COVER SHEET CIVIL PLANS FORTRESS - PUYALLUP

Job Number 22085 Sheet C1 of 34

No.	Date	By	Chd.	Appr.	Revision
2	03/05/24	DL	DL	JSG	RESPONSE TO CITY COMMENTS, DATED FEBRUARY 06, 2024
	02/27/24	DL	DL	JSG	BID SET
1	12/06/23	DL	DL	JSG	RESPONSE TO CITY COMMENTS, DATED 10-06-2023

Job Number: **22085**  
Sheet: **C4** of **34**

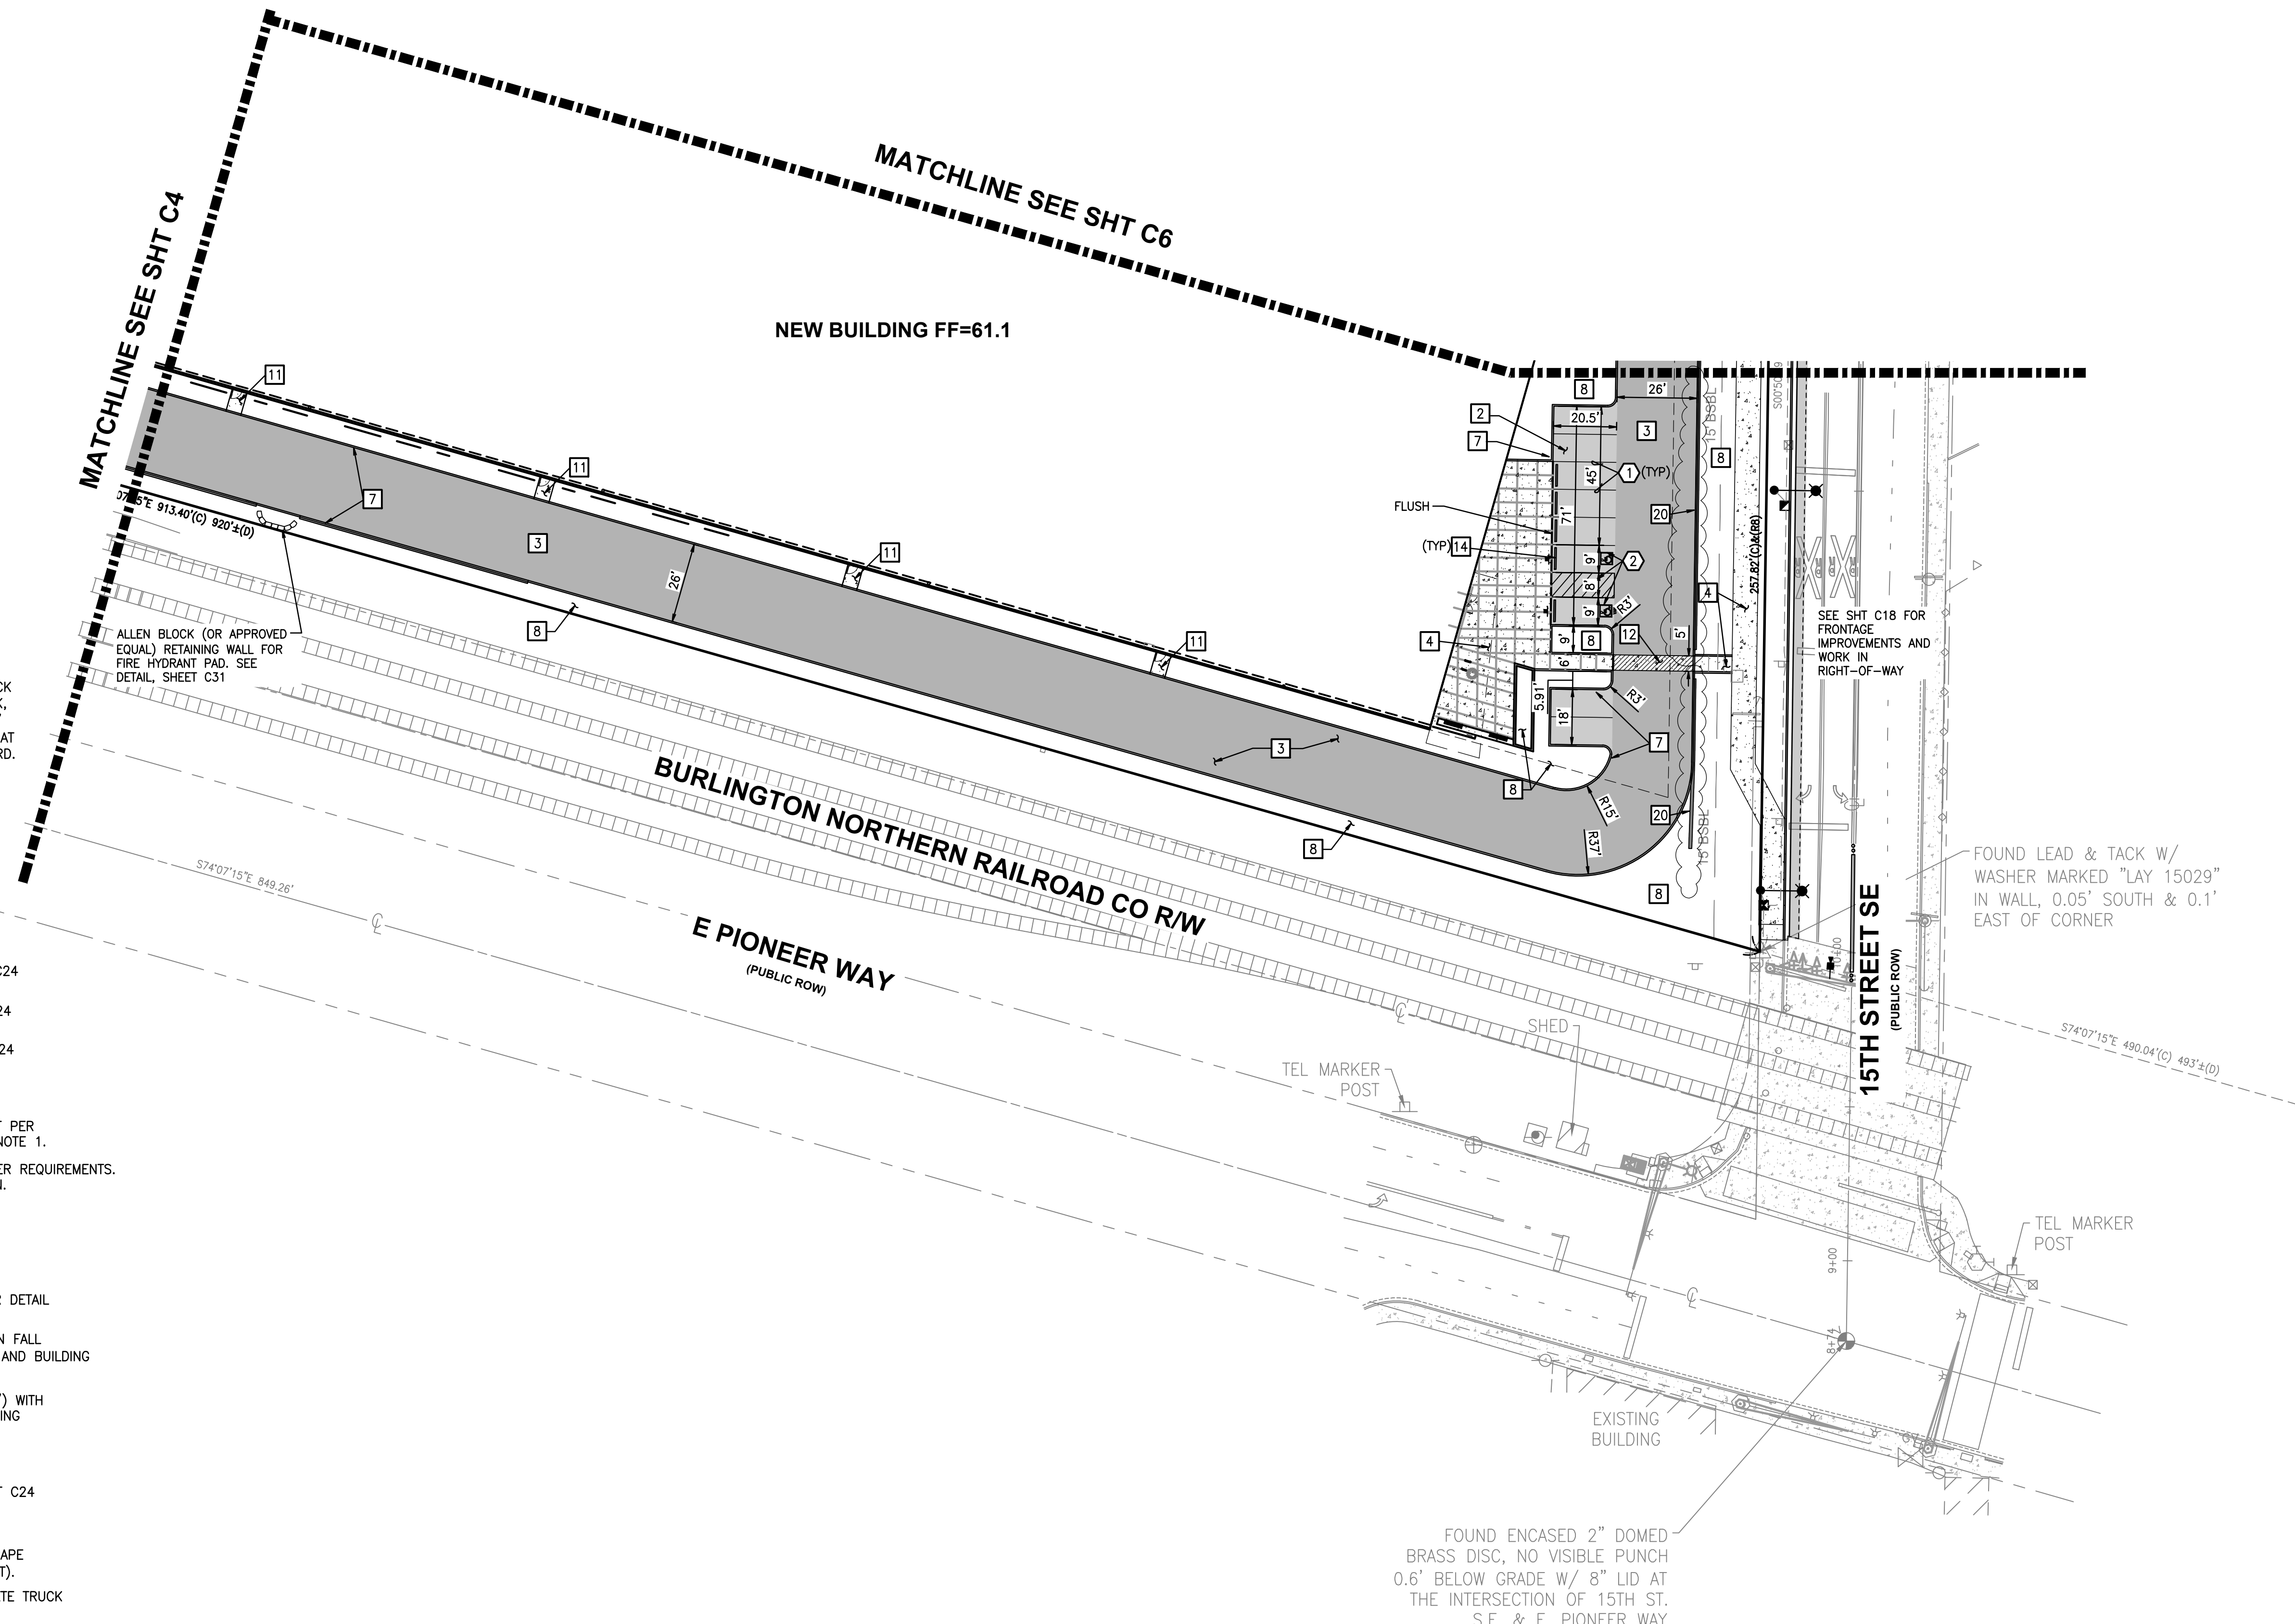
What set of Geotech plans is this referring to? (civils, pg 4)

callout revised to reflect actual wall design (separate building permit)

Job Number: **22085**  
Sheet: **C7** of **34**

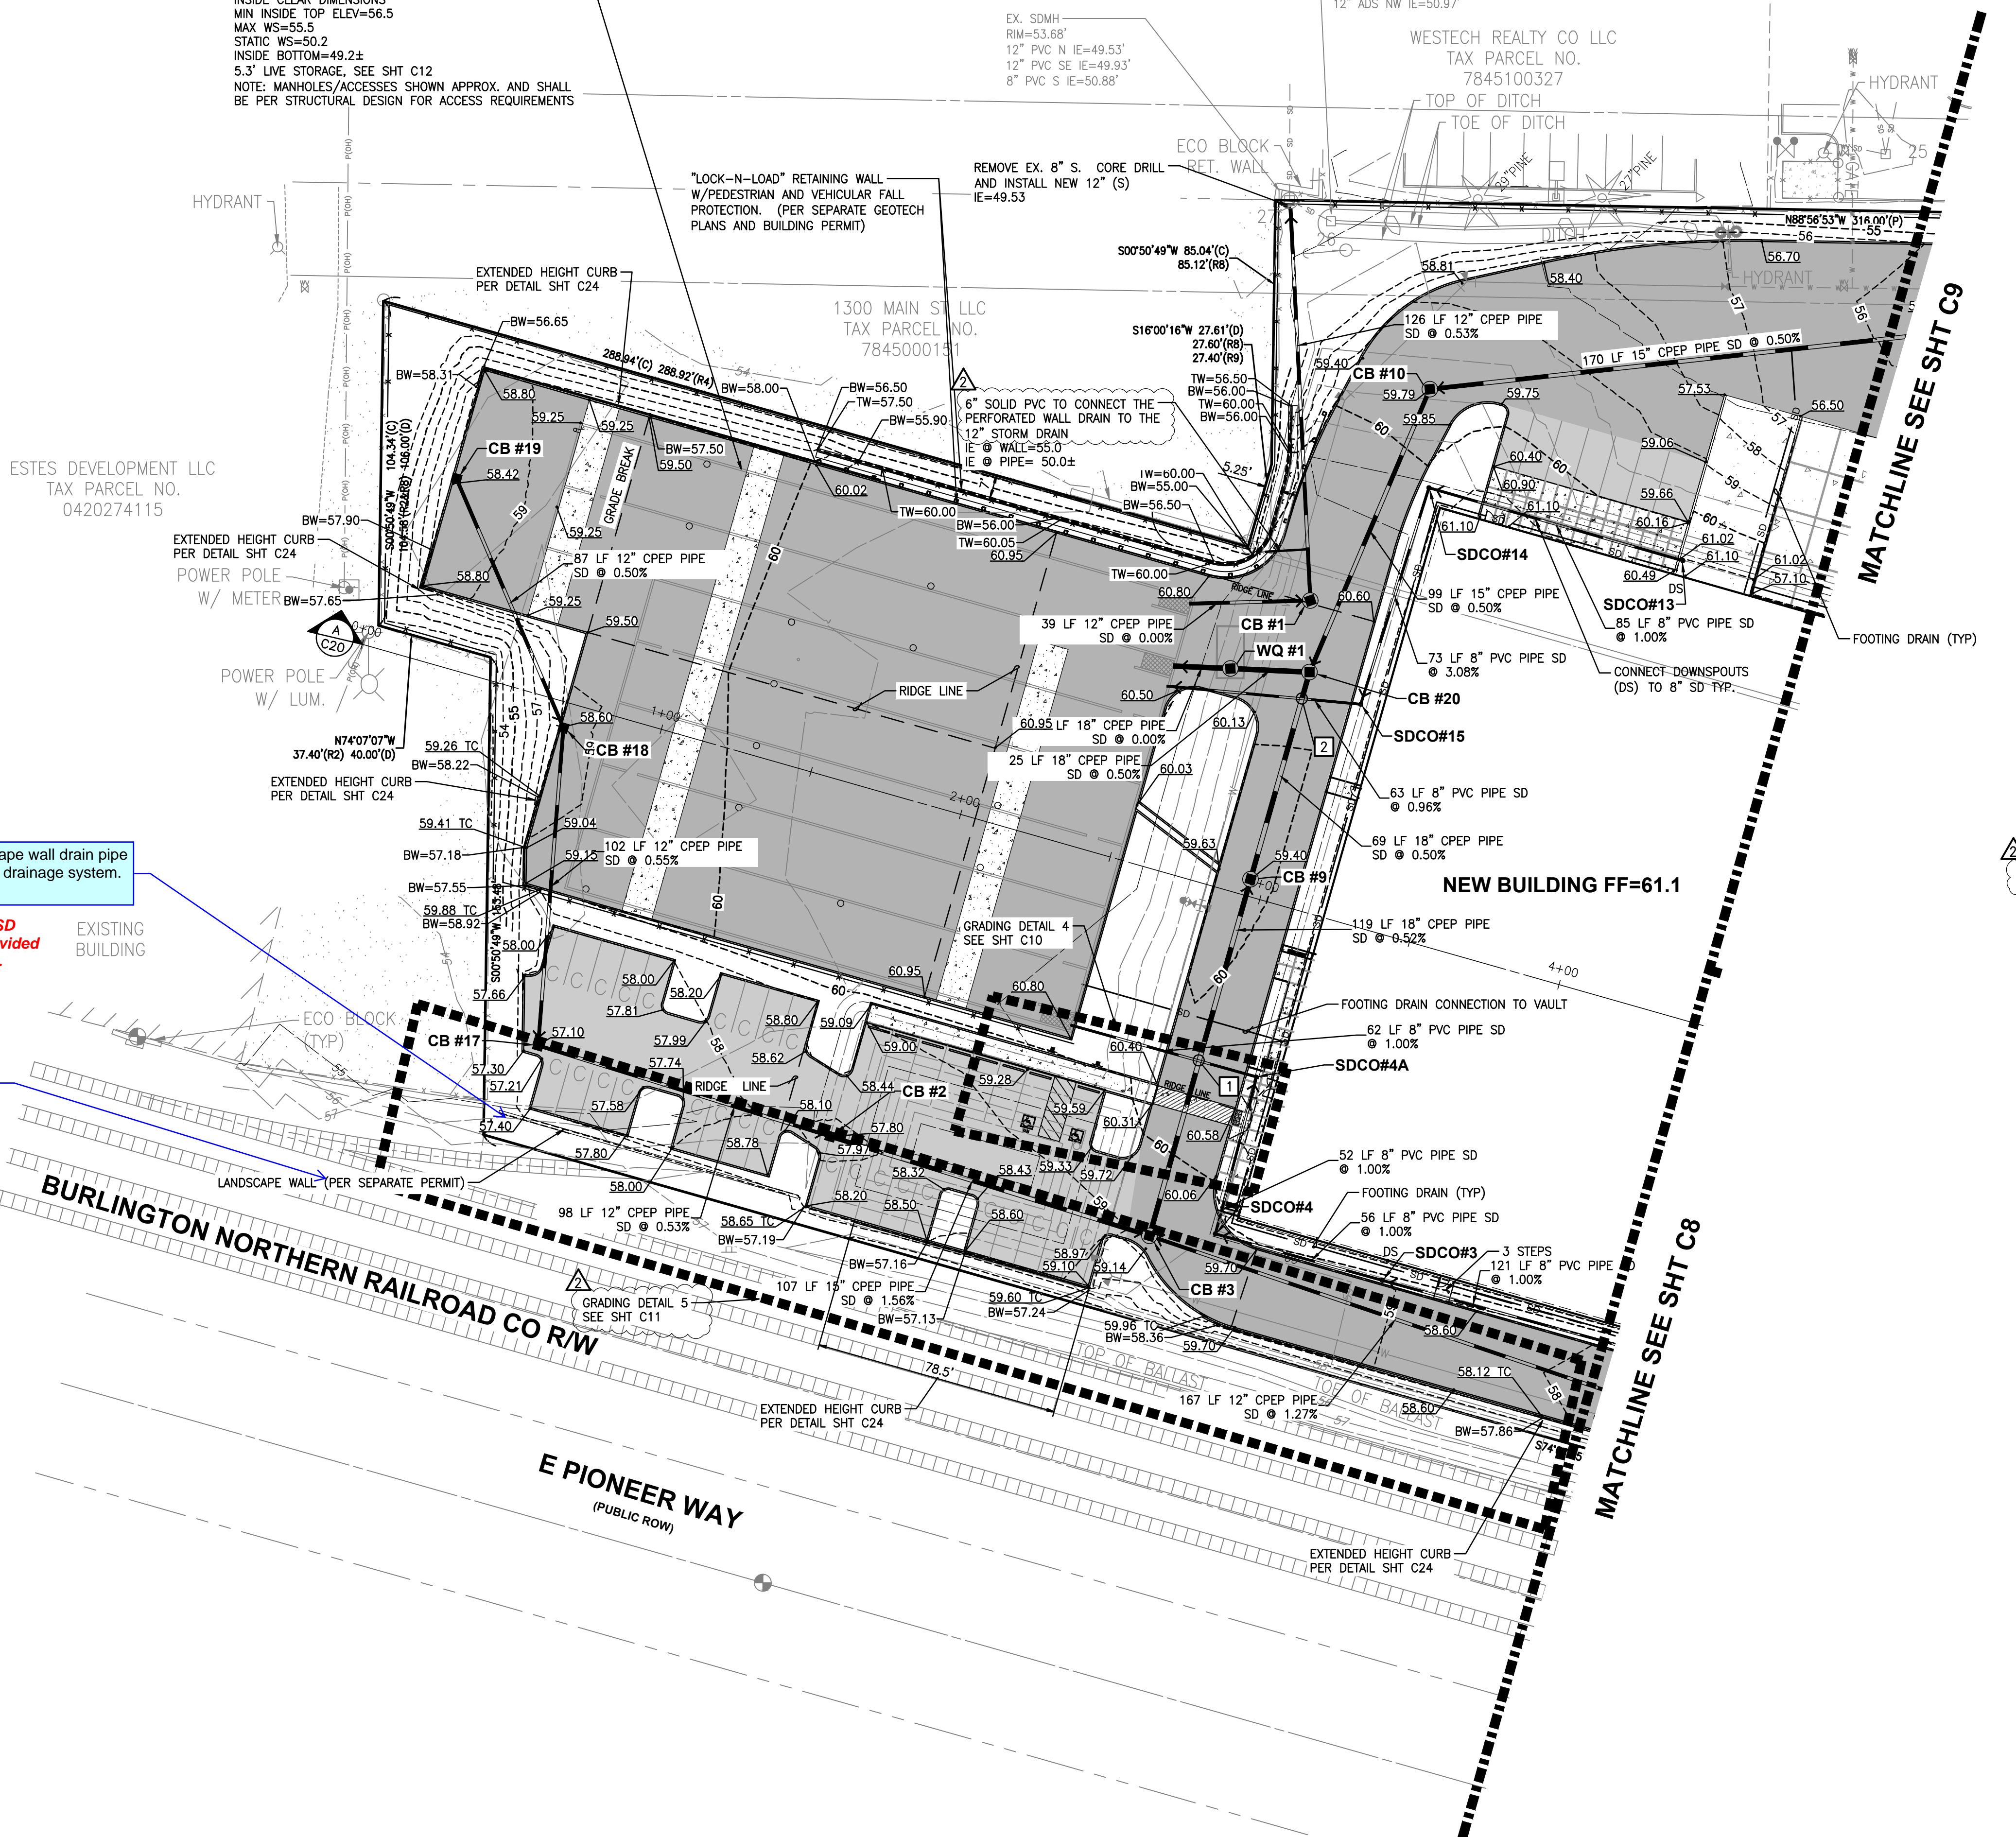
Show the landscape wall drain pipe connected to the drainage system. [civils, sheet 7]

Reference the landscape plans as well, 5/L5.10. [civils, sheet 7]

Wall reference added to plan.

Note number 8 added for required wall drainage.

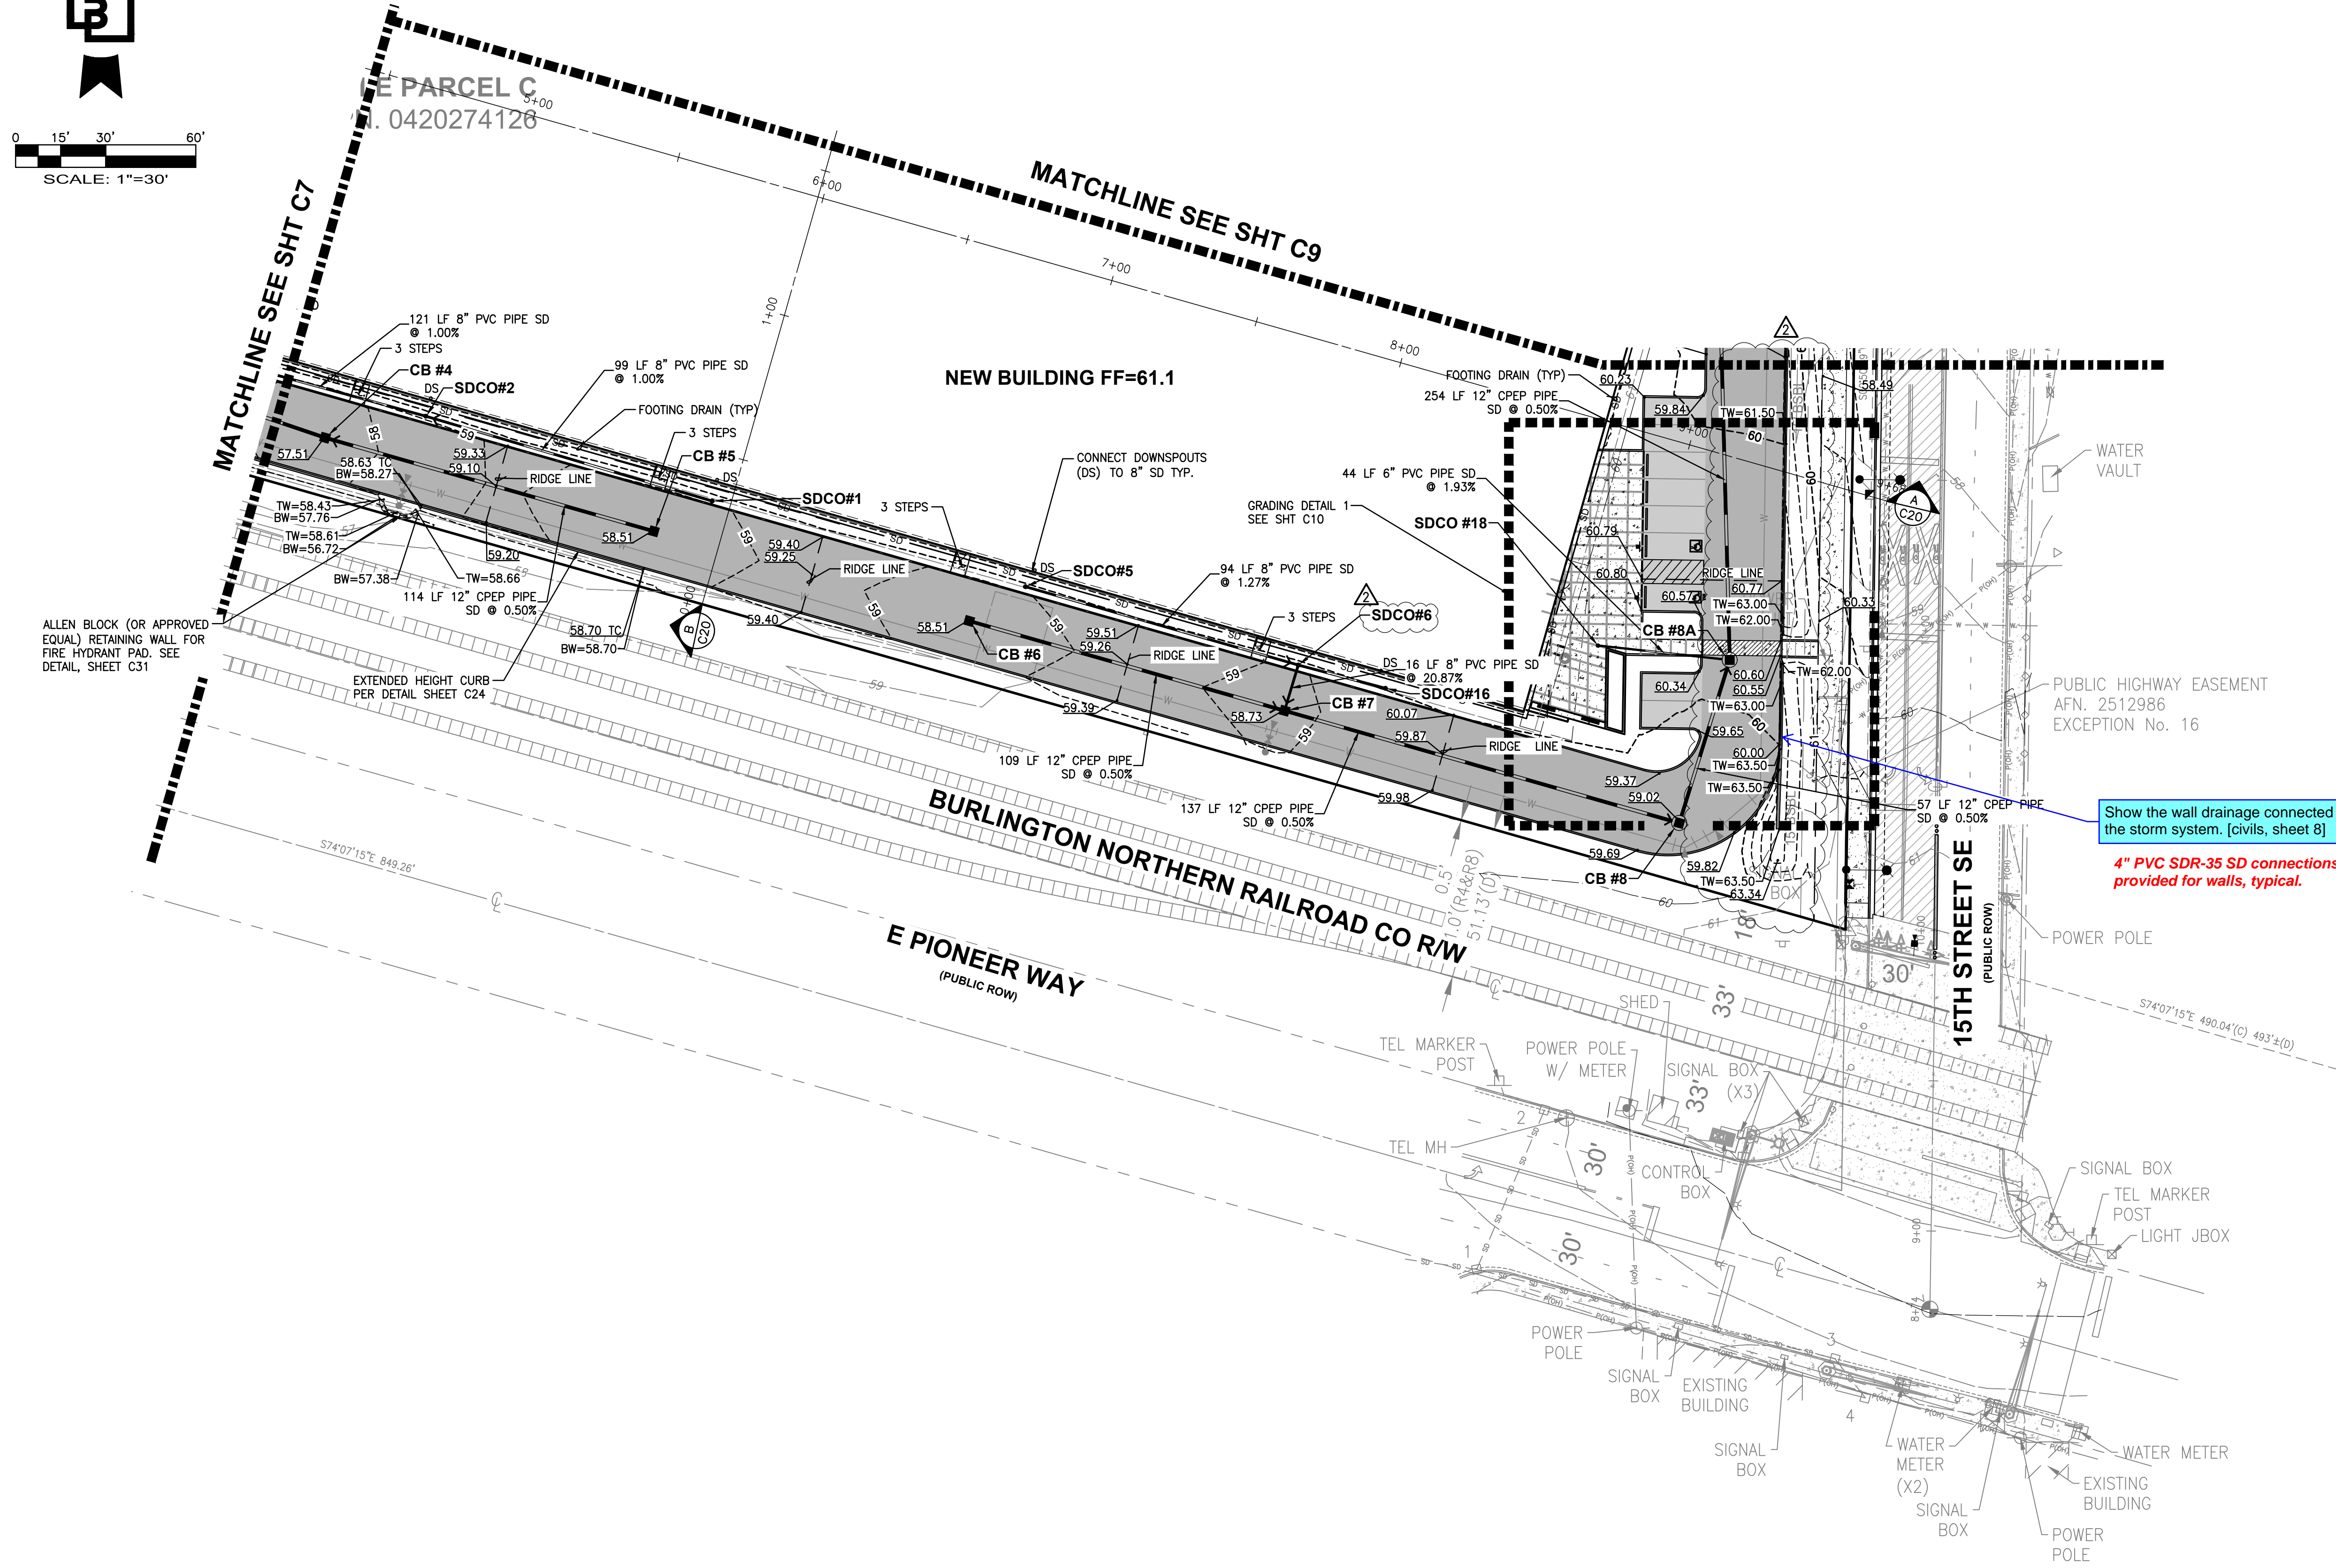
Show the wall drainage connected to the storm system. [civils, sheet 8]  
**4" PVC SDR-35 SD connections provided for walls, typical.**
